PCN-276382

Product Change Notice

Smart Display AllnGaP Green and Red LED Supplier Change

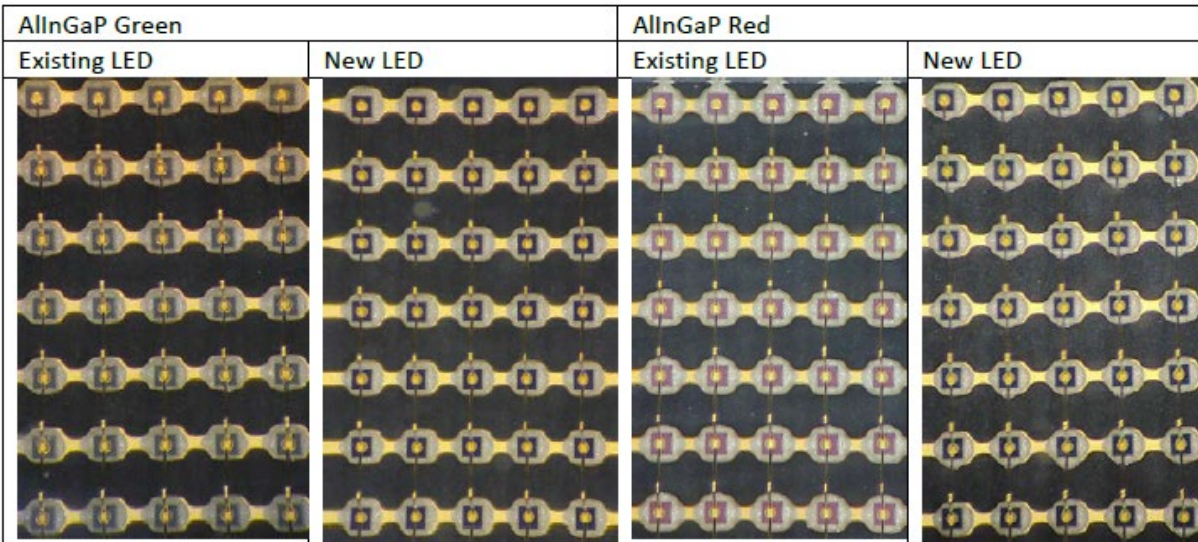
There will be changes in the below characteristics:

1. LED physical appearance
